July 25, 2025

RE: Lake Hills- Phase 1 Final Subdivision Plans Review

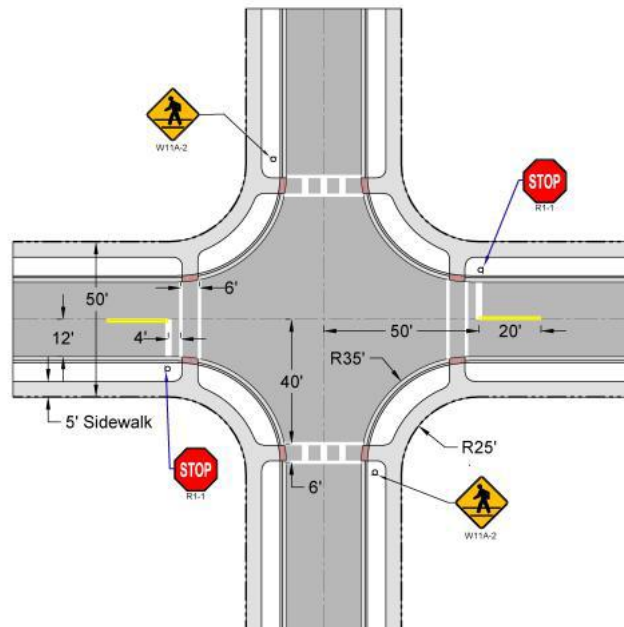
Comment 9: Lake Hills PUD is to be designed as a Complete Streets, pedestrian friendly community. The intersections of the residential streets need to provide full pedestrian accommodation. Pedestrians need to have clearly designated means (crosswalks & signage) to safely traverse an intersection from any corner to any other corner or side. Intersection design needs to meet that intent and comply as much as possible with the town's road detail R1A. Curb ramps need to be perpendicular to the road and not placed at the center of the corner radius. The distance from the intersection of the nonstop crosswalks can vary to align with lot lines and not conflict with driveways.

Response 9: *The towns detail conflicts with FDOT's standard for stop bars adjacent to travel ways. For safety purposes, a stop bar should be no further than 30' from a*

travel way, with a 35' radius, crosswalk, and separation to the stop bar this would not be feasible to maintain. Our proposed configuration supports a safe passage for both the pedestrian and motorist.
